# CITY OF PORTLAND, MAINE

RE: Cumberland Avenue Parking Garage, Corner of Cumberland Avenue, Preble Street and Elm Street

**RE:** Cumberland Avenue Parking Garage Site Plan - August Corp.

Figure 11  
PROPOSED LANE MARKINGS - PORTLAND STREET ACCESS

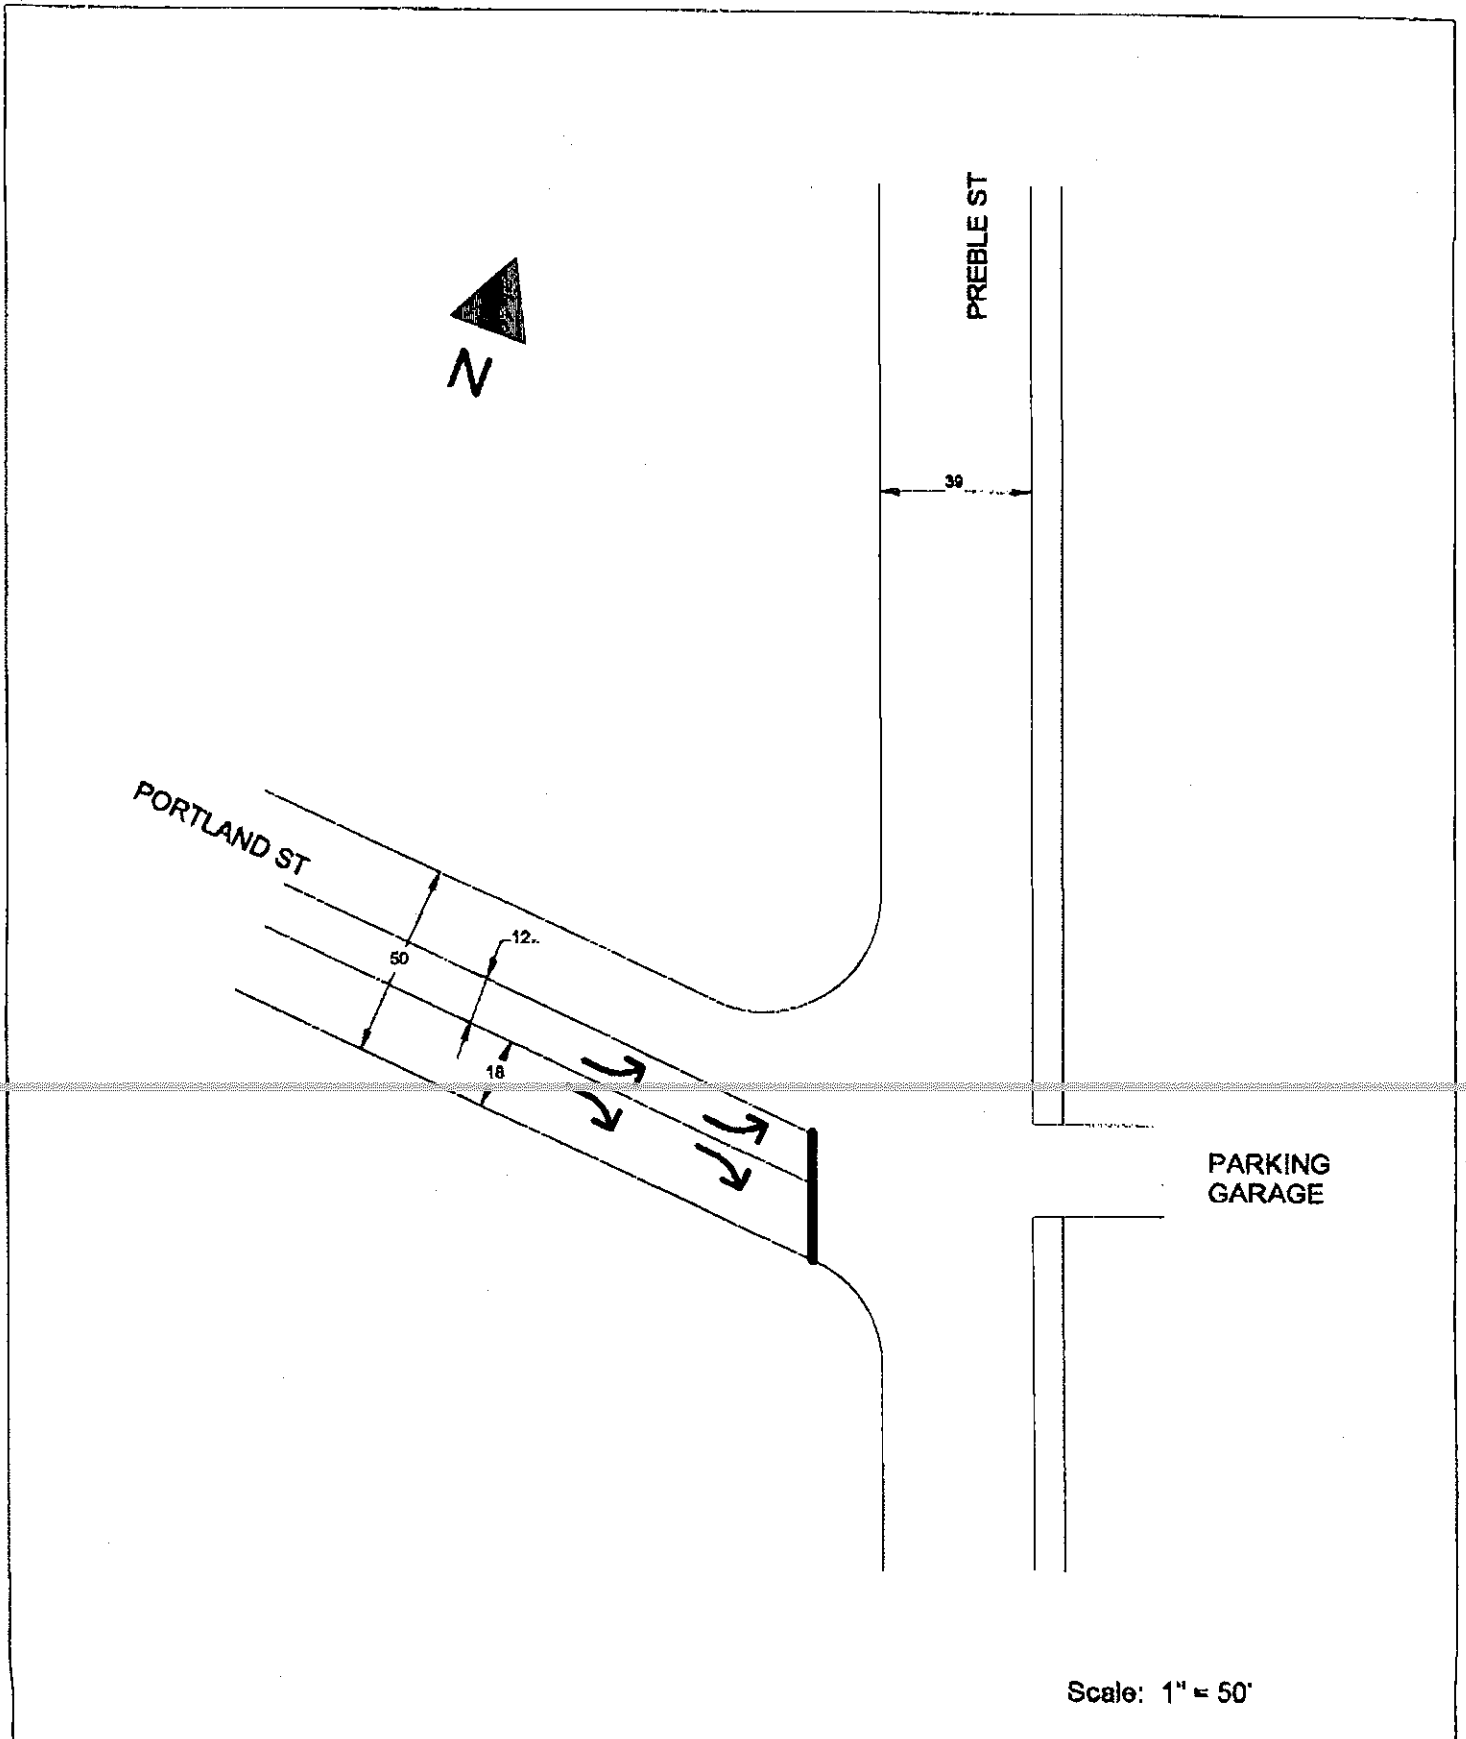
The proposed site plan addresses traffic related concerns. Rather than installing the traffic island in Portland Street up front, I would suggest a trial period of one year (upon operation of the parking garage) to observe whether actual field conditions require it. After this trial period, we will review whether the island is warranted. However, should it become obvious during this period that the island is needed, I would like the flexibility to require it at that point rather than waiting for the entire trial period to end.
